Technical Bulletin 12/1/2014

### ***Tillotson HW27A Carb Butterfly(Shutter)***

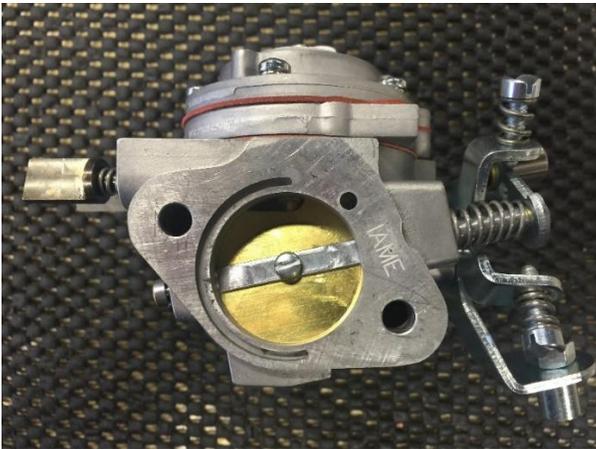
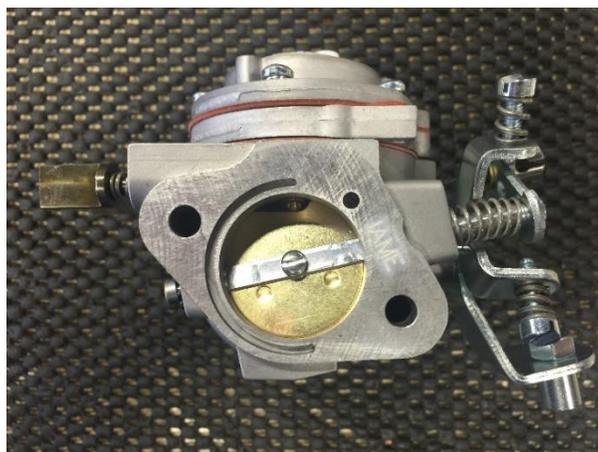
Please note that the butterfly(shutter) included in some of the new Tillotson HW27A carburetors that are being supplied on the market do not come with “dimples” as you can see in the pictures attached. If the owner does not tighten the butterfly screw properly, the butterfly can keep the throttle open slightly. Tillotson has used this as their standard butterfly for a while now without issue, but we have asked for this to be supplied in the future with the “dimpled” butterfly. Should you have one that doesn’t have the dimples, we will trade this out to you free of charge. Please contact IAME USA East for a replacement or your local IAME dealer.

Picture above shows butterfly without “dimples”, and shows butterfly in slightly open position if not tightened properly.

Pictured here with “dimples”.
